ADDENDUM 04

PROJECT:	Exeter Twp ESC	MWS PROJECT NO:	25-049
ADDRESS:	70 Gibraltar Road		
	Reading, PA 19606	ISSUE DATE:	10/30/2026*

C105

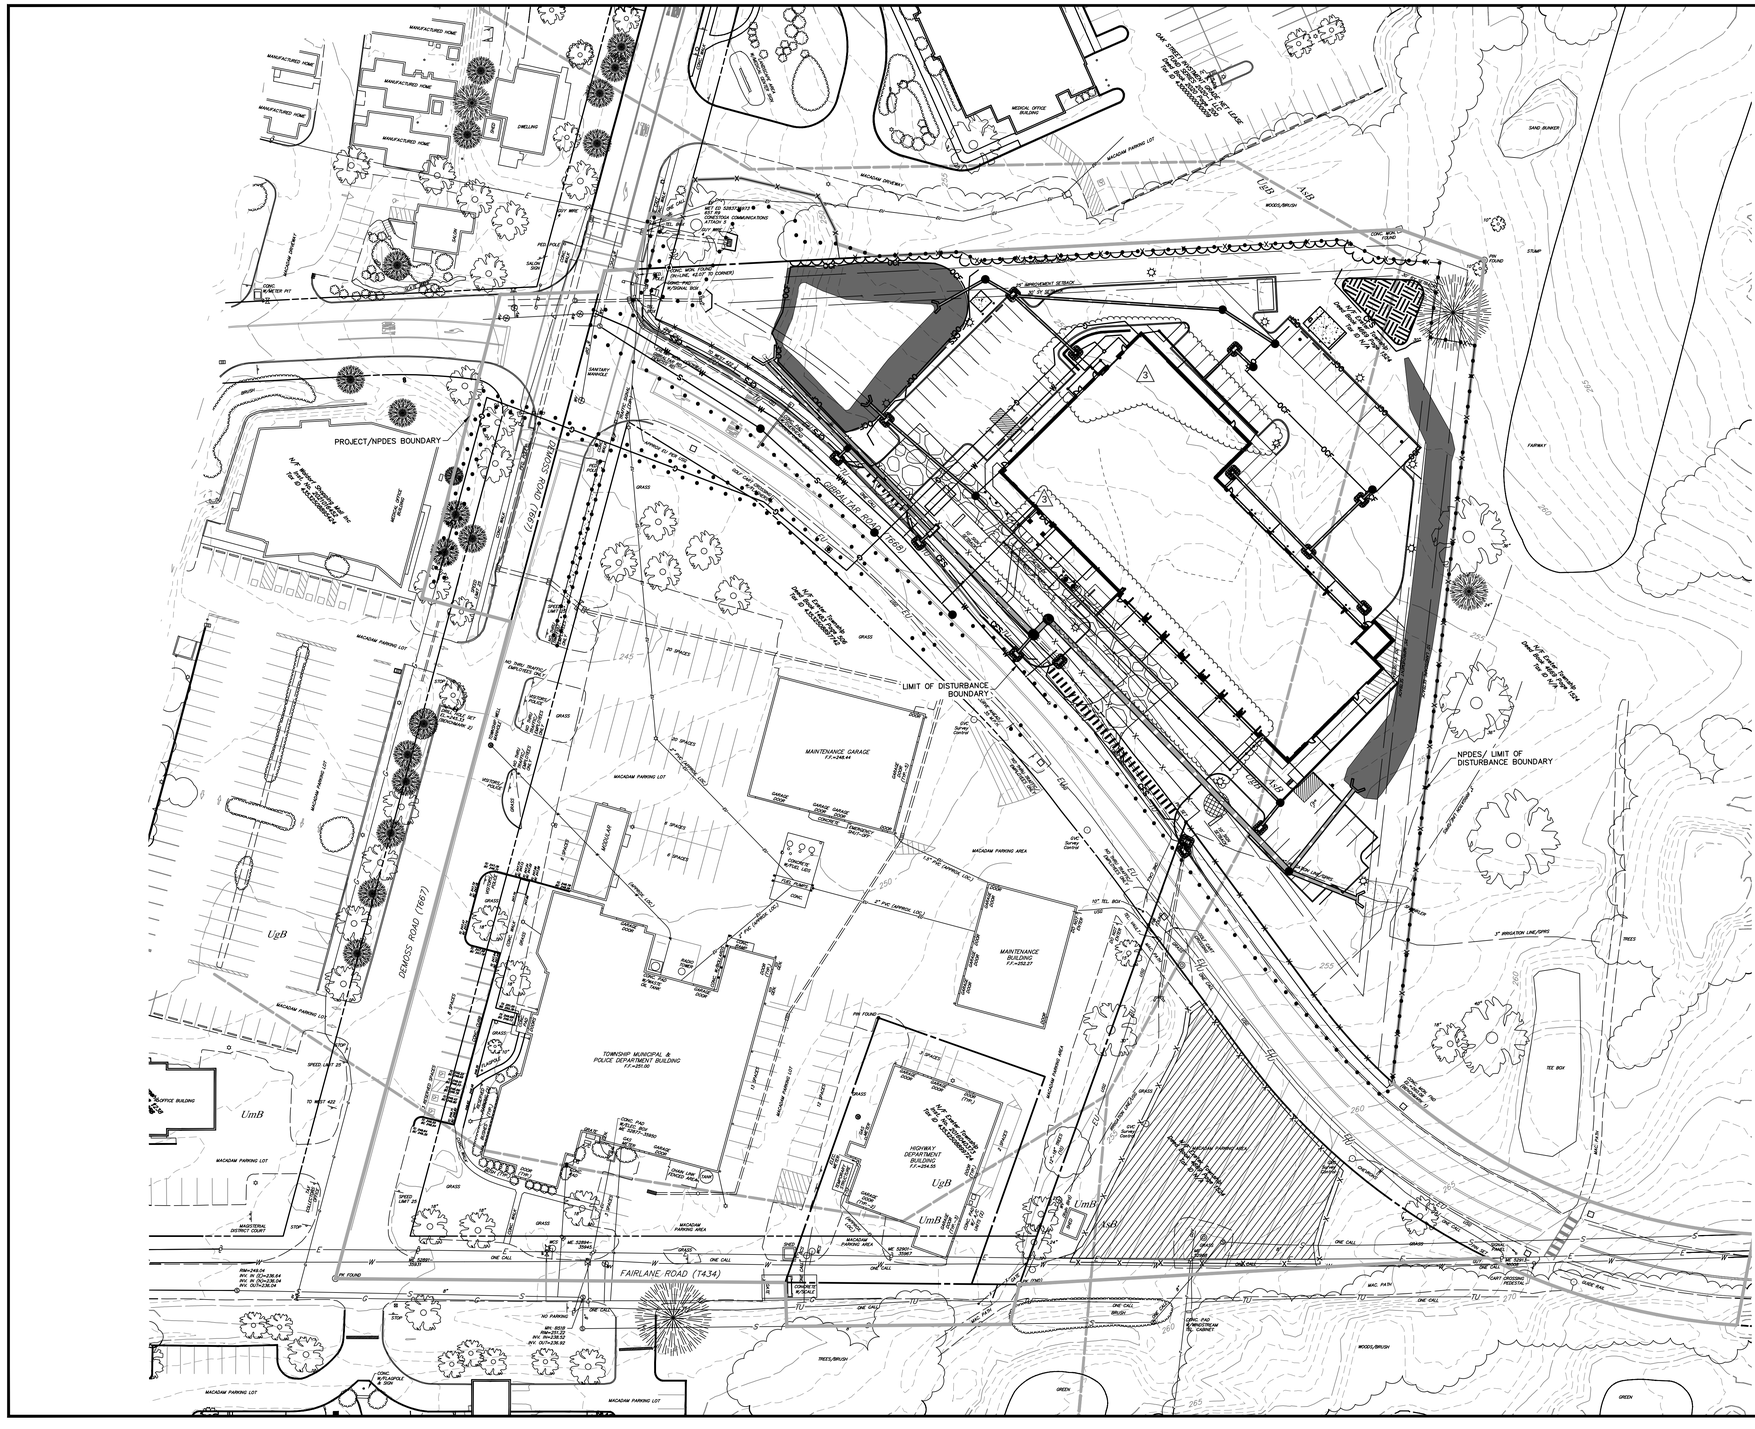
15.) E&S Plan (C105 & C106) - Revised sanitary cleanouts and traps for consistency with Profiles. Revised roof drains to show 26 total. Revised gas service to grills for consistency with Plumbing Plan. Revised gas box drain pipe to discharge to Inlet (I-2B.3.1).

STORM CLEANOUT DETAIL IN PAVED AREAS

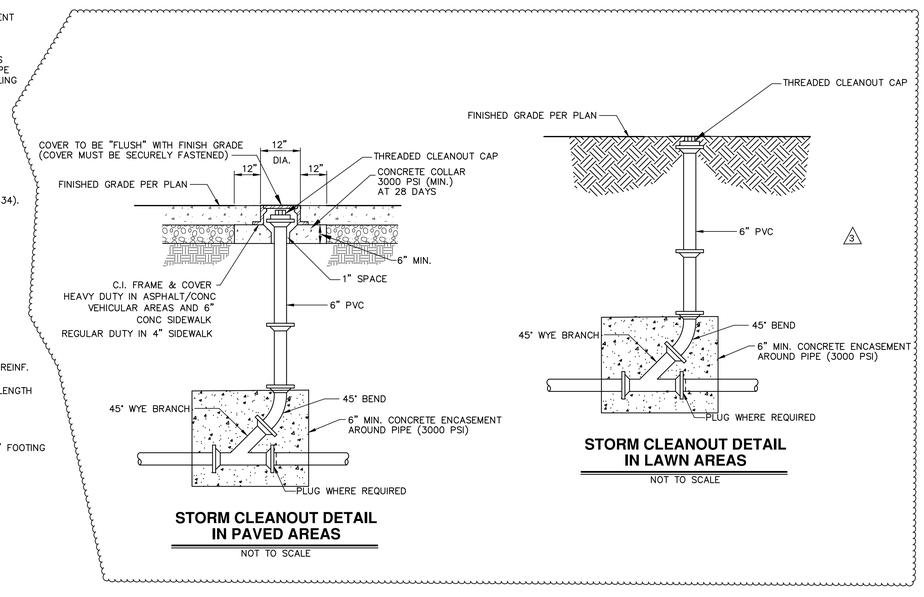
13.) Details (C25 & C211) – Added two (2) storm cleanout details.
